PROJECT NO. 278-91 (91-206)

PROJECT Water Control Structure at
Salt Bayou

Review of Aviles Report
on Salt Bayou Water Control Structure

BORING 91-206

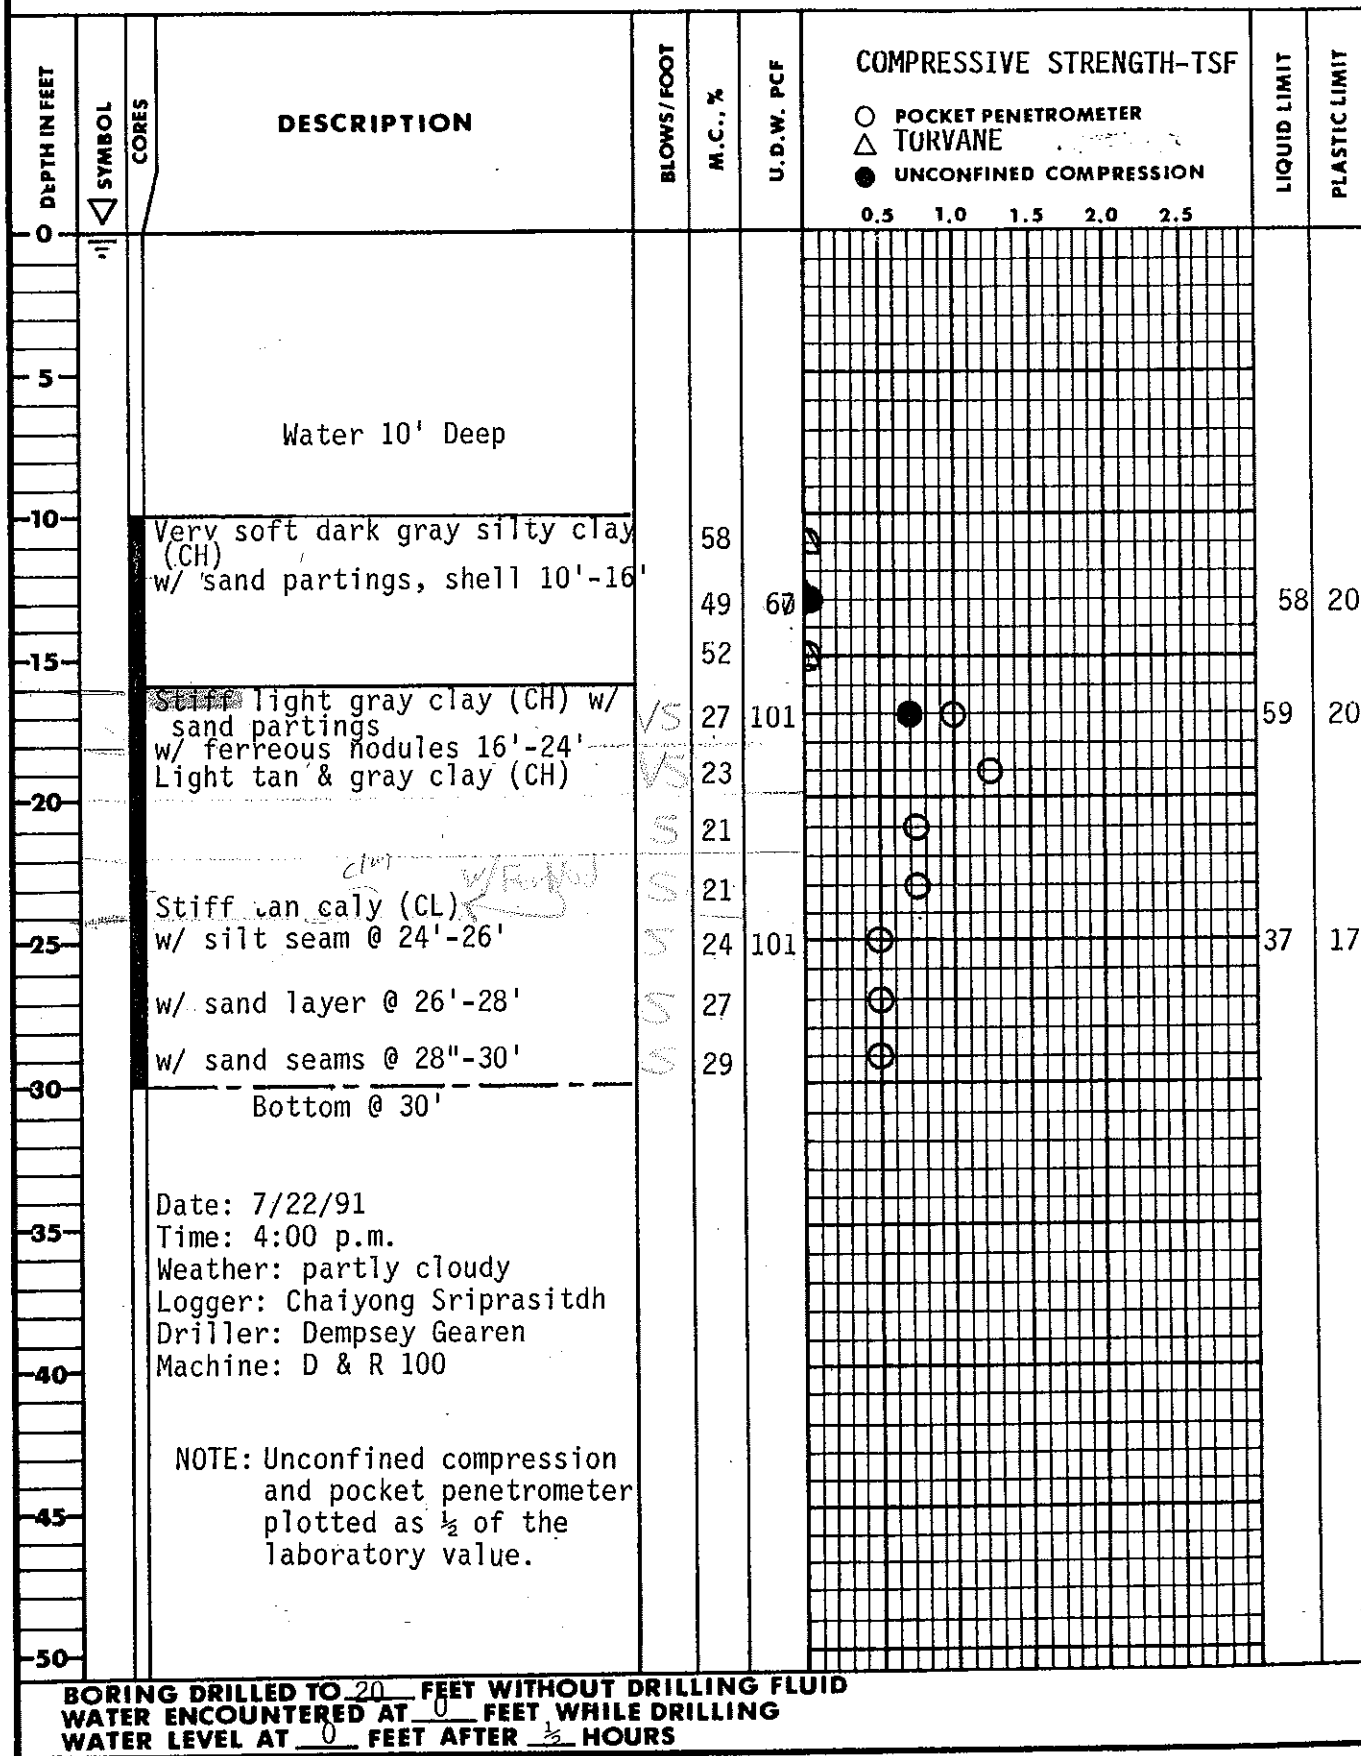
Sample 2 from Borings No. 91-206 appears to have this unreasonable relationship.

UNCONFINED COMPRESSION TEST
STRESS-STRAIN DIAGRAM

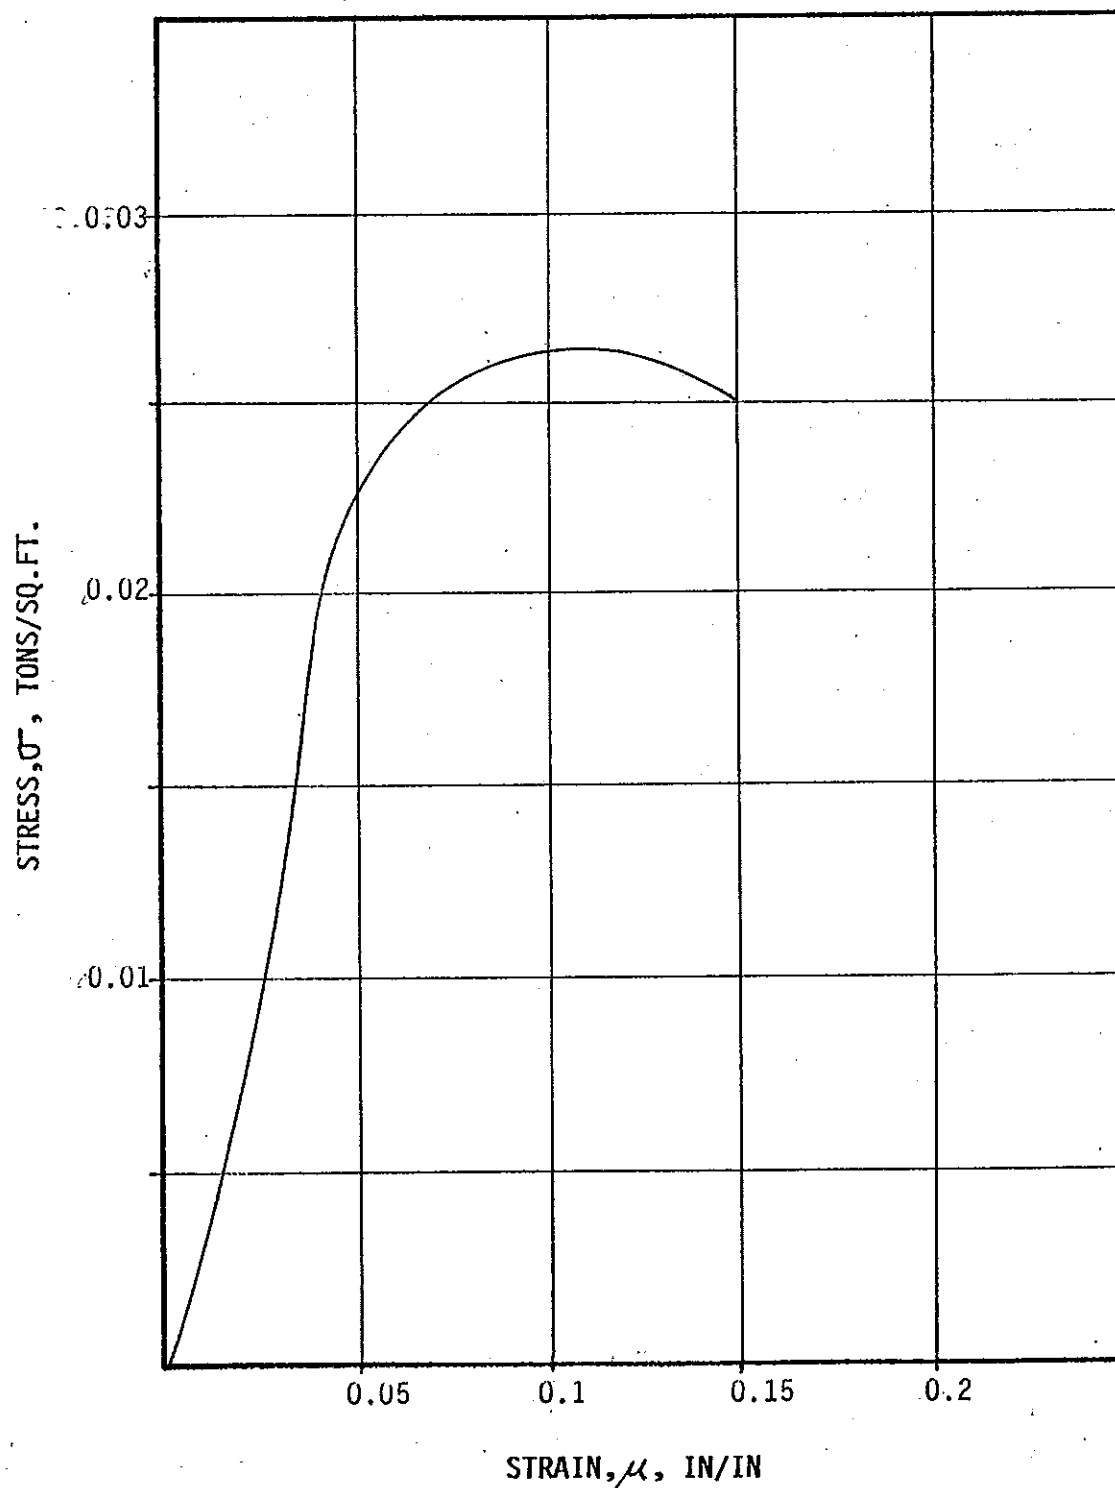
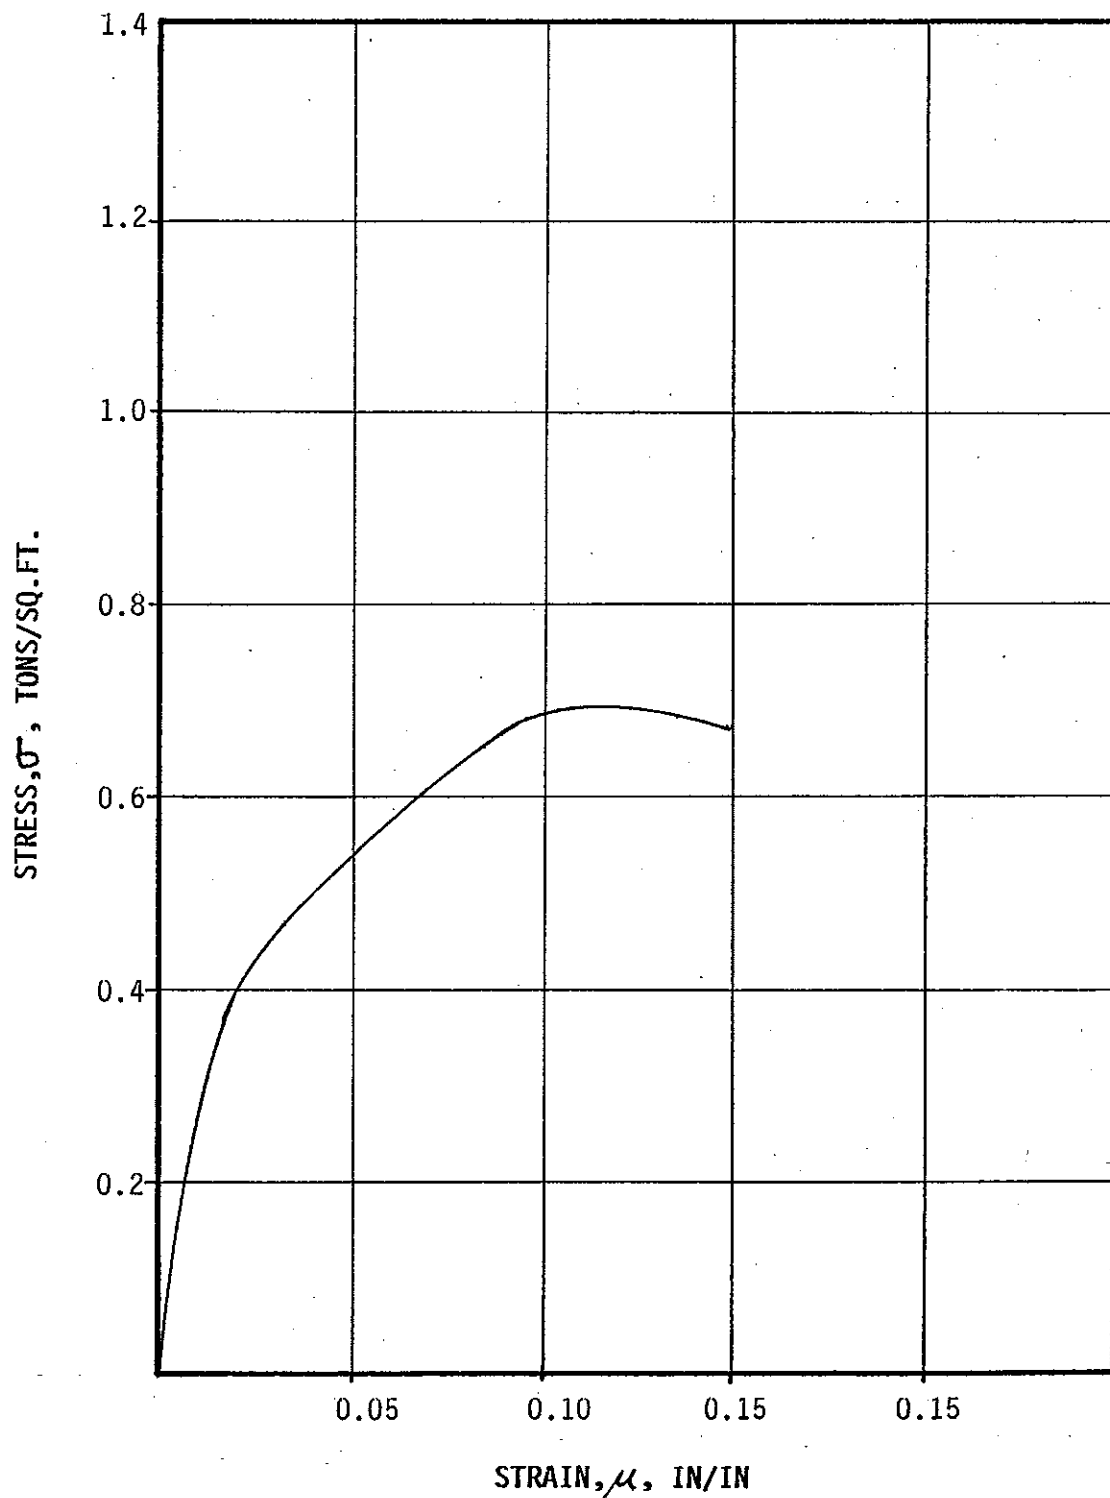
1. The plates showing description of materials, moisture content, unit dry weight, shear strength and atterberg limits are somewhat misleading. The presentation of unconfined compressive stress as a shear strength does ^{not} ~~not~~ appear appropriate. Shear strength is usually taken as one half the unconfined compressive stress.
